SAN FRANCISCO UNIFIED SCHOOL DISTRICT
2011 PROPOSITION A BOND PROGRAM
ROOSEVELT MIDDLE SCHOOL

ADDENDUM NO. 1

PROJECT: Roosevelt Middle School
Boiler Replacement Project

DATE: March 24, 2015

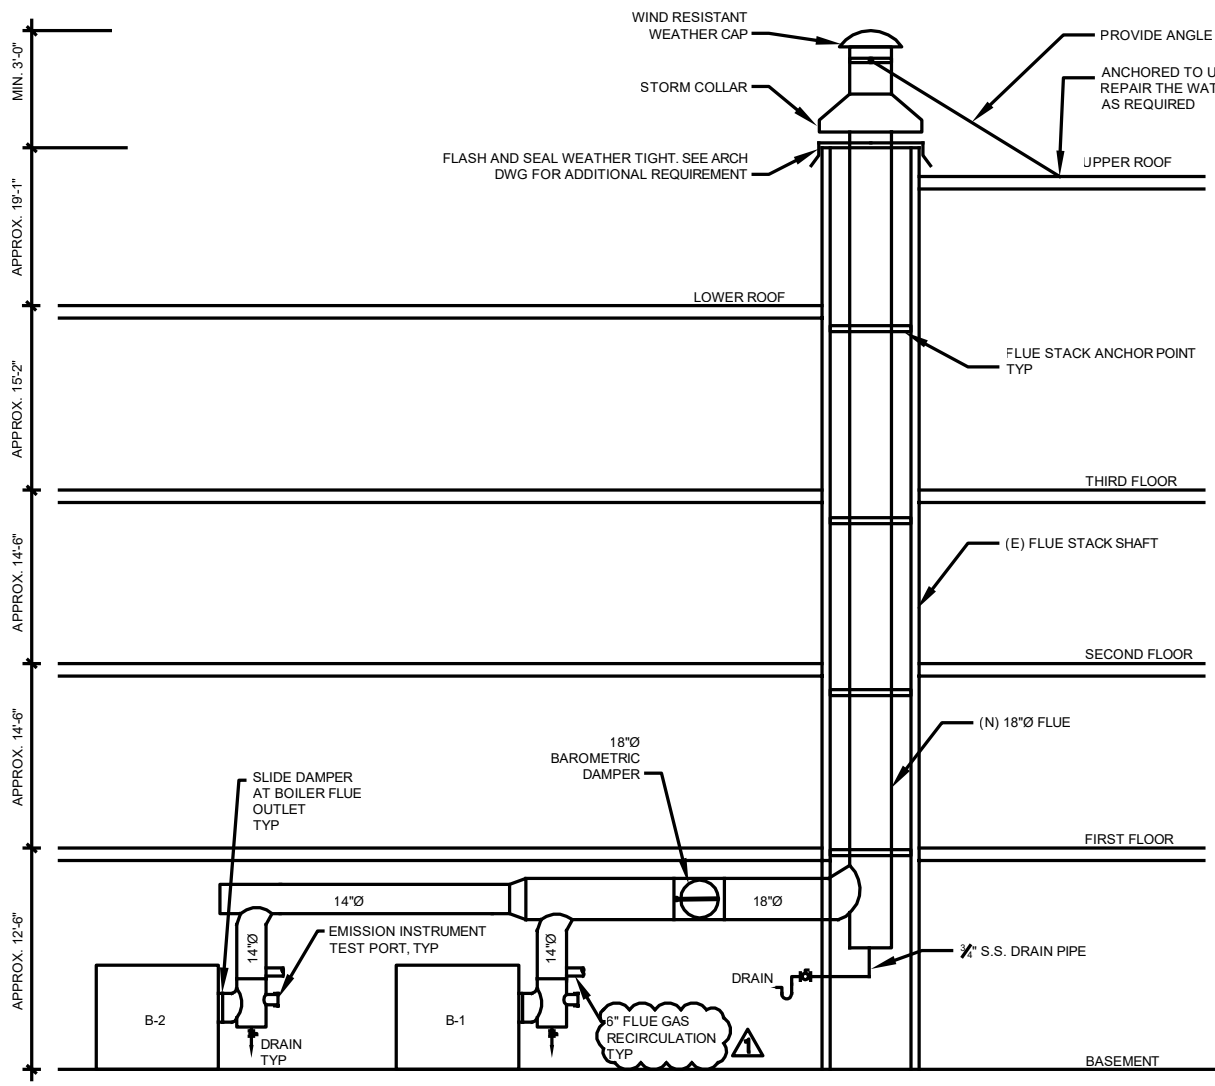
D01C.11 QUESTION: Plan E0.02 – Shows a new electrical service to the new panel EC which calls for 250 amp breaker with 250MCM cable and 2-1/2" conduit to a calculated load requirement of 58 amps.

Two – ¾ HP Pumps @ 230/3/60 = 3.2 FLA each

Two – 3 HP Pumps @ 230/3/60 = 9.6 FLA each (Plus 120/1/60 CCT @? KVA)

Two – 1.5 HP Burners @ 230/3/60 = 6.0 FLA each (Plus 120/1/60 CCT @? KVA)

This could be better serviced by a 100 amp breaker with #2 wire and 1" conduit. This will reduce the costs for electrical on this project.

RESPONSE: The rating of the new panel is to match the existing spare breaker in the MSB. It is acceptable to downsize to 100A as proposed. Contractor shall remove existing spare breaker in MSB and provide new 100A/3P breaker to feed new panel. Submit due credit for review and approval prior to proceeding with the change. If the contractor decided to reuse the existing spare breaker as indicated on E0.02 instead of providing new 100A breaker. Please be aware that the existing breaker is actually 200A/3P, not 250A/3P as indicated in the single line. New panel and new feeder should be downsized accordingly to match the 200A breaker.
